MODIFICATION RECOMMENDED - CORRECTS MANUFACTURING OR DESIGN DEFECTS

6692A-02

SERVICE NOTE

6692A DC POWER SUPPLY

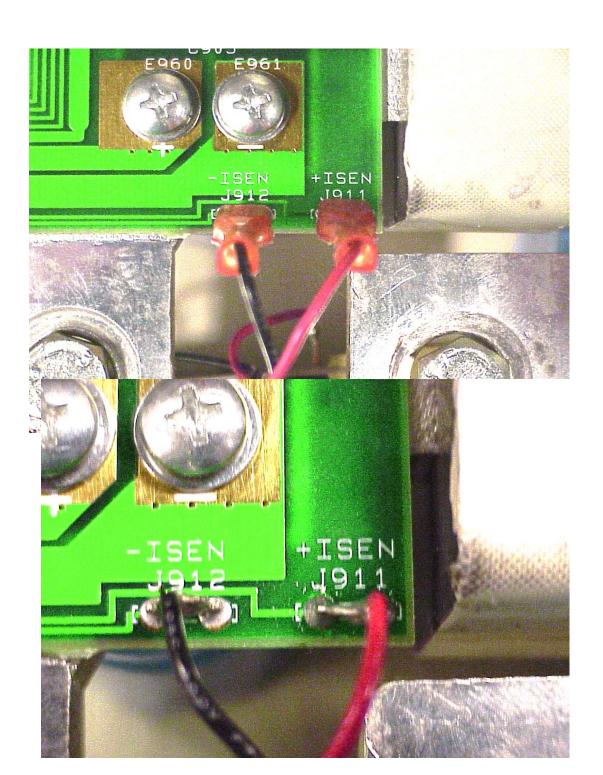
The Current Shunt (Circuit Reference "R900") may have intermittent sense wires, which may cause Instability of Current Regulation, Current read back and current programming may become unstable.

When the push-on connectors become intermittent the output current will become unstable. Loose push-on connectors can cause the output current to change dramatically. The current can change from any set current, and may go to the maximum rated output current of the instrument.

The first picture below shows how the Shunt "R900" is connected using the term-crimp connectors. The Shunt "R900" is connected to (-ISEN J912 Black wire) & (+ISEN J911 Red wire).

The second and the third pictures show how the Shunt "R900" is connected when soldered.

Cut the terminal-crimp connectors off of both wires and discard the connectors. Make this cut as close to the terminal-crimp connector as possible. Carefully strip the wires to approximately 8mm and solder the wires, and avoid burning the wire insulation and the printed circuit board.

This strip length will be used to solder to the connectors to (-ISEN J912 Black wire) & (+ISEN J911 Red wire). The length of these wires is critical. If the strip length of the wires is too long, the wires may cause a short to adjacent components. If the length of the wires is too short the solder connections may be poor. If replacement of the Red or the Black wire is required the same type and color wire should be used (22 AWG. 300V 105C).

The wires should be connected as shown below. The holes in the male connectors should be used to solder the Red and Black wires to the printed circuit assembly marked (–ISEN J912) & (+ISEN J911). Do not mix the Red & Black wires when making this modification. See picture below for details. The pictures shown below show the required modification.

- 1. Inspect the solder connections to determine the solder joints are acceptable.
- 2. Inspect the printed circuit board to insure the solder joints are acceptable around (-ISEN J912) & (+ISEN J911) connectors.
- 3. The wires that are now soldered to (-ISEN J912 Black wire) & (+ISEN J911 Red wire) MUST be twisted.
